ADDENDUM NO. 1

**RE: RFP-DOT-14-15-5005-TRK
Central Florida Rail Corridor (CFRC) Track Renewal and Grade Crossing
Upgrades, FM NO. 412994-4-52-11**

You are hereby notified that the above referenced Request for Proposal (RFP) is modified as shown below:

Colonial Drive Crossing Future Roadway Widening

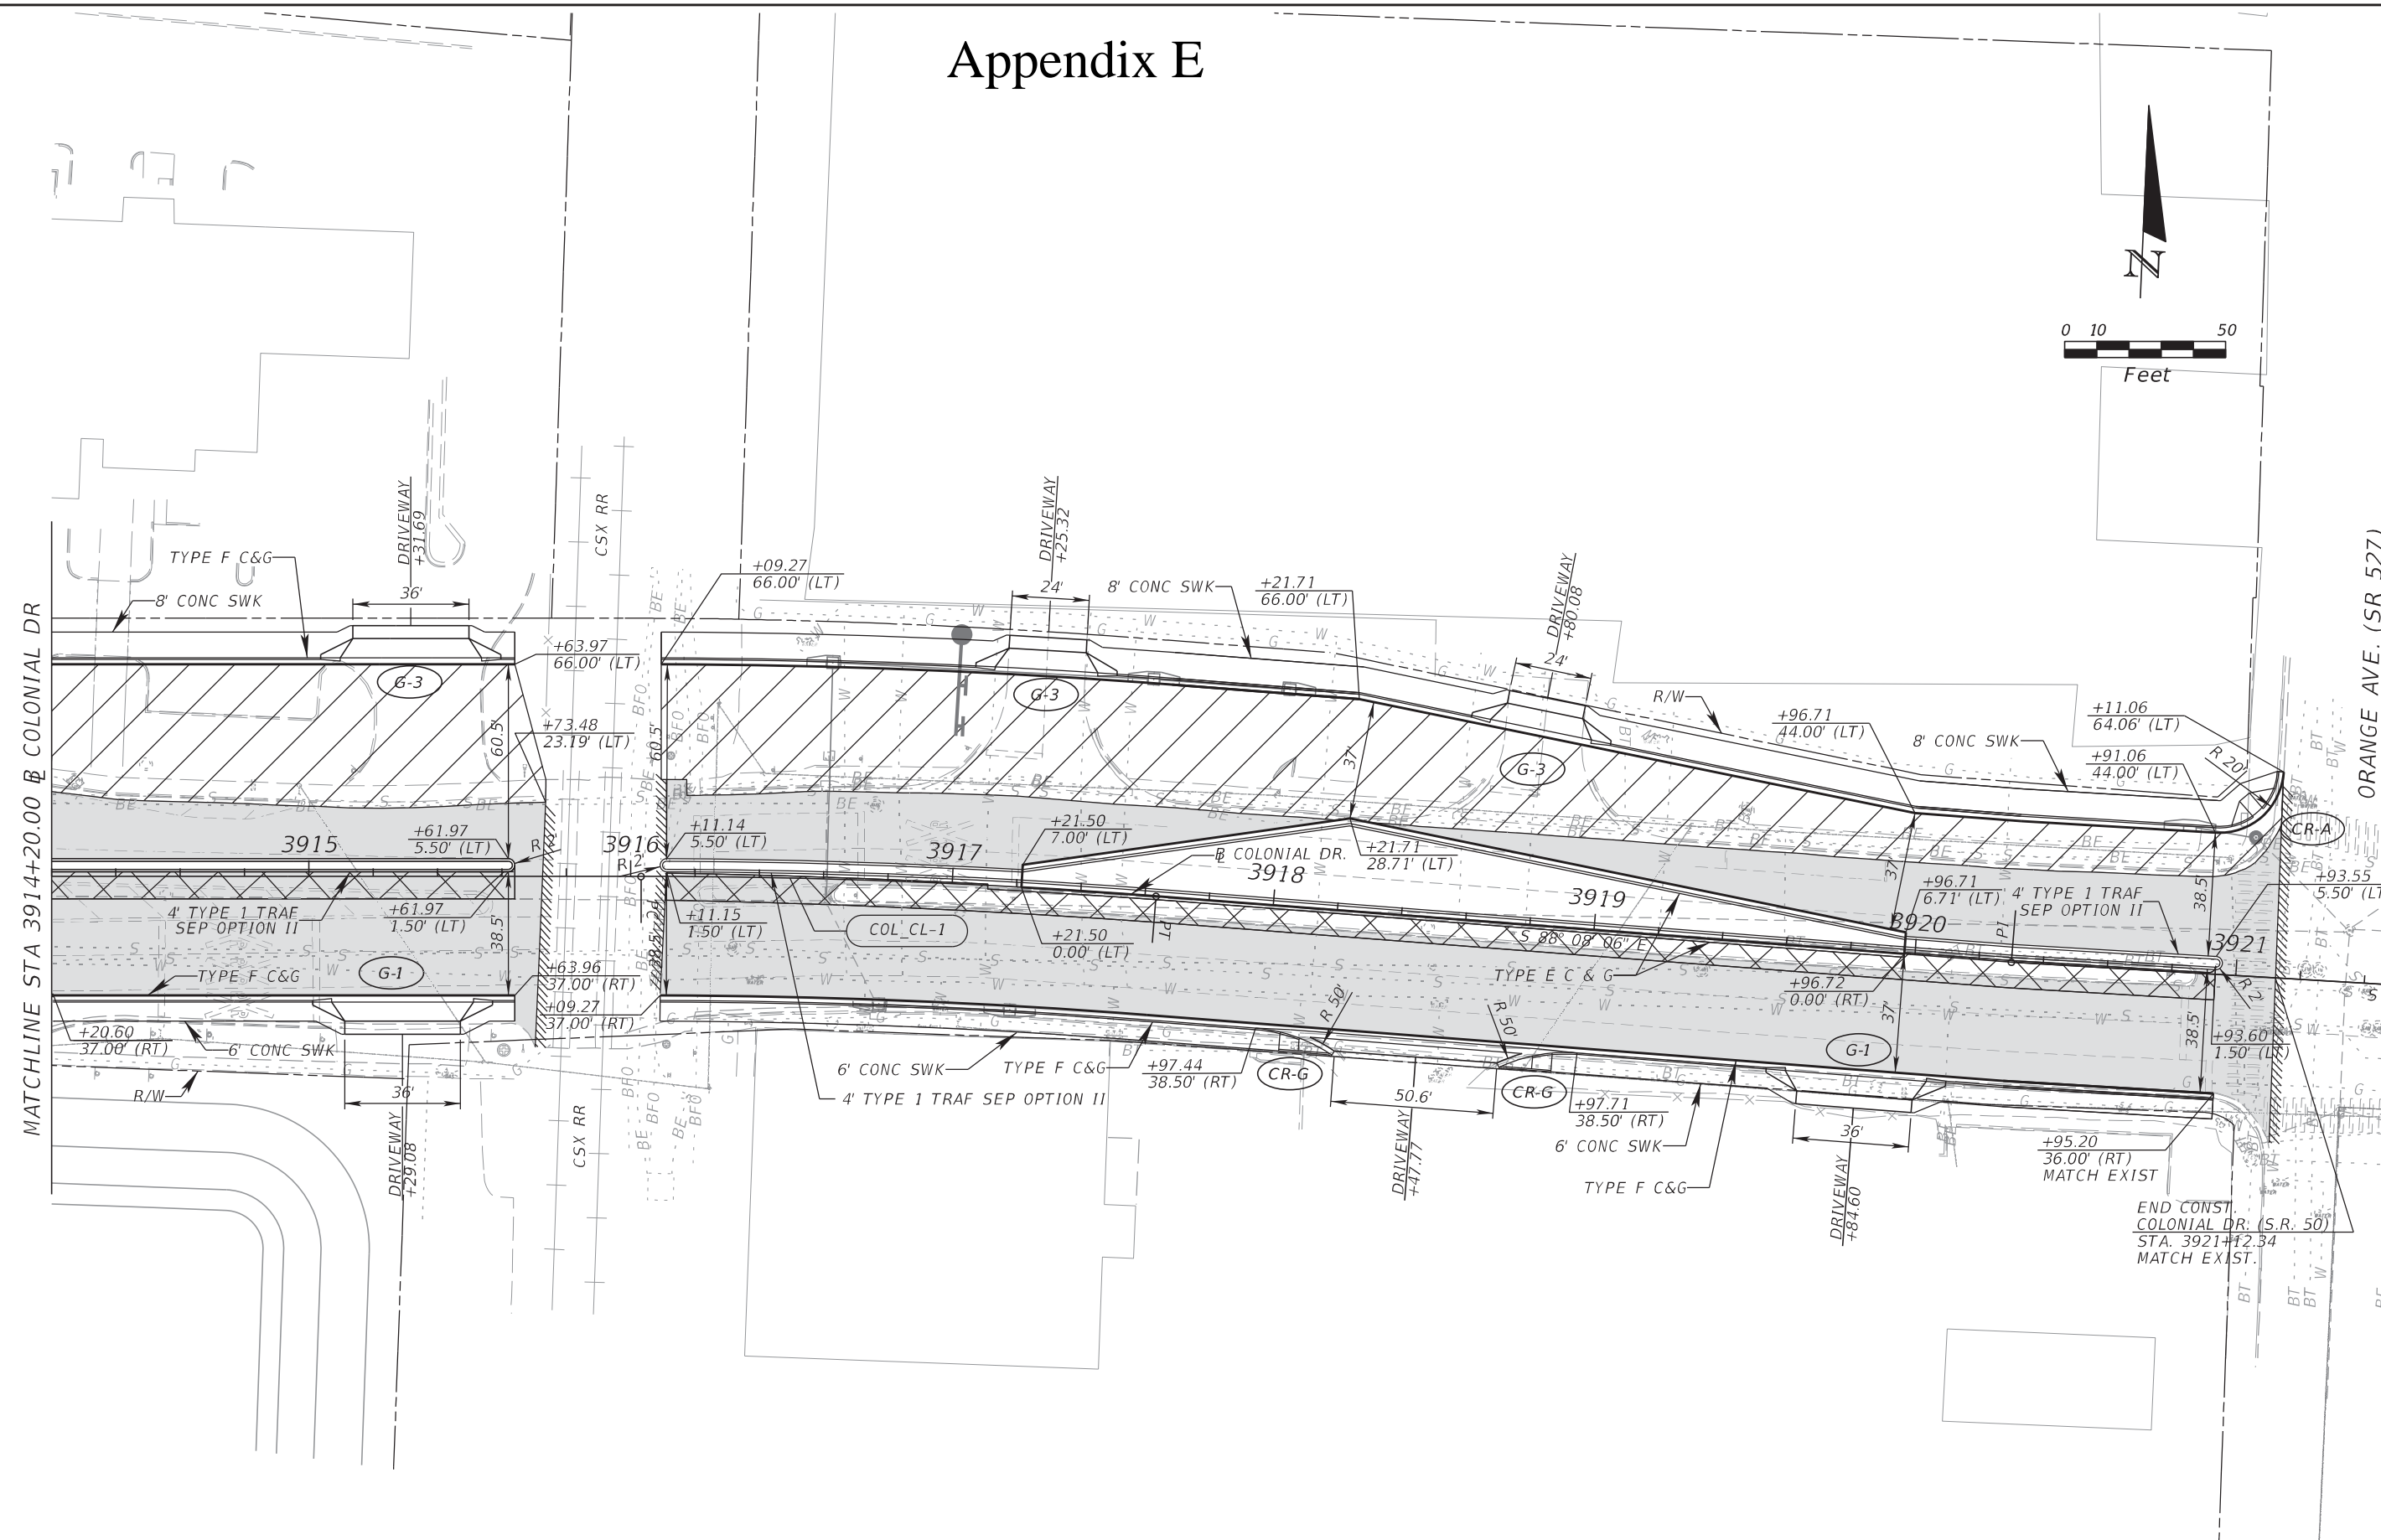
789.48 W. Colonial Dr. Upgrade Tracks 1 & 2 1 [180 2883](#) 9 p.m. Friday to 3a.m. Monday
[3 – Existing Track 1 and Track 2 crossings are 90 feet each. The W. Colonial Drive grade crossing is planned for widening to the north. Extend the track upgrades 54 feet to the north on both tracks to accommodate the future widening. See Appendix E for the W. Colonial Drive Roadway Widening Plan Sheet.](#)

³ – [Existing Track 1 and Track 2 crossings are 90 feet each. The W. Colonial Drive grade crossing is planned for widening to the north. Extend the track upgrades 54 feet to the north on both tracks to accommodate the future widening. See Appendix E for the W. Colonial Drive Roadway Widening Plan Sheet.](#)
